MINUTES OF THE MEETING

December 6, 2007

Seattle Design Commission

6 December 2007 **Project:** University Link, UW Station and Pedestrian Bridge

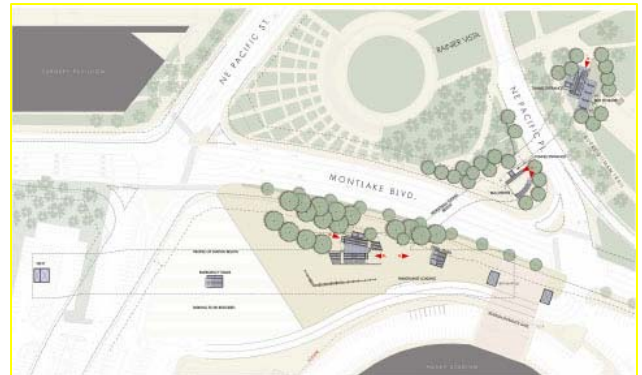
- Station box remains the same
- 500 foot tunnel into mezzanine space
- Tunnel construction impact; need to temporarily close Montlake Blvd. lanes in phases.
- From the north entrance, need to descend 30 feet to pedestrian tunnel; would require major excavation
- Tunnel devoted to station, while bridge is more of a universal connector
- One would see the bridge not in its entirety but as a series of vignettes, one crossing at a time
- Visual impact of bridge is low
- Allows for views that don't currently exist

U Link Pedestrian Bridge Plan

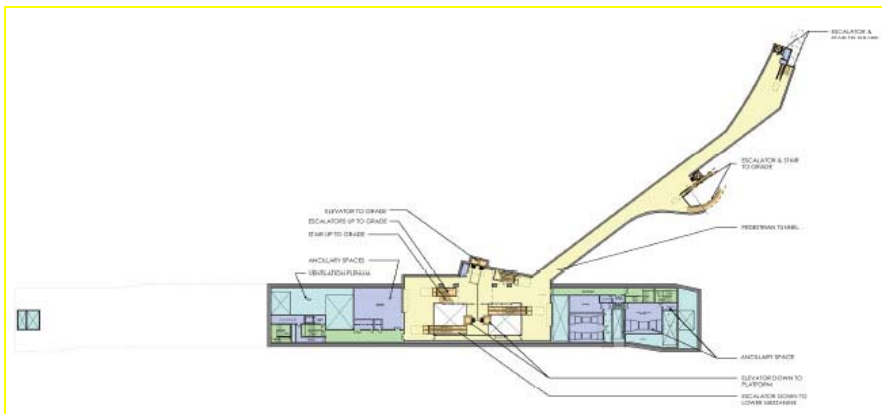
- Bridge is compelling in diagram but not integrated with features that connect it to grade and the station
- Seems rather undeveloped
- Cross section of bridge at triangle looks clunky

- Bring arc into it in elevation
 - o Looked at other possibilities, but want profile to be simple and sleek
 - o Bar grate railing to pronounce the sweep

- o Need to work on lighting
 - o Don't want massive gesture
- Needs to be modeled in 3D, not convincing in drawing. Looks like a cheap bridge, insignificant. Details make the difference. At 30% design it's hard to see the details. Don't do off the shelf stuff.

- Is railing curved or in segments?
 - o Small segments
- Connections to ground need visual connectivity. Look like functional units that are not integrated.

- Like to see a foot wide bike ramp along stairs.
- Lighting should be integrated into the structure.
- Landing point needs to respond to where it lands. Need good transition.

- Bridge becomes emblem of station. Don't see design evolution of the sculptural piece.
- Could introduce other curved forms to better integrate station pieces.
